Certificate of Appropriateness

Property 939 N. 31st St. Concordia HD

Date issued 10/10/2019 PTS ID 114873 COA porch rehab

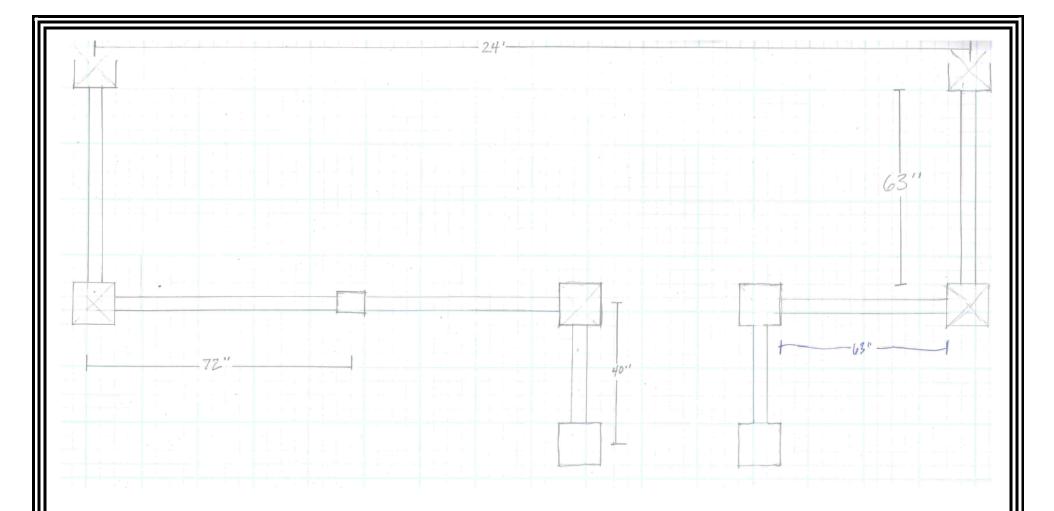
Photos from the Wisconsin Historical Society
Work to be done on lower front porch ONLY – second photo indicates baluster design to be maintained

Drawing above indicates dimension for lower front porch

Guard rails and balusters to be replaced to match existing design, painted to match existing condition upon completion.

Structural posts and newel posts will be repaired as needed and painted to match existing condition

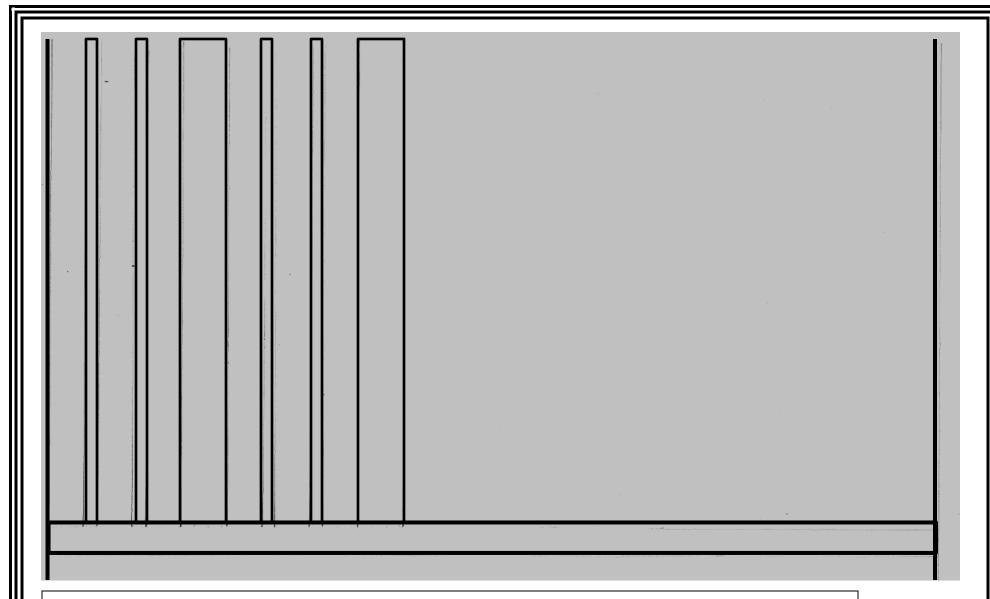
Skirting will remain

Sketch of baluster profile and design to be maintained – new balusters to match existing conditions exactly
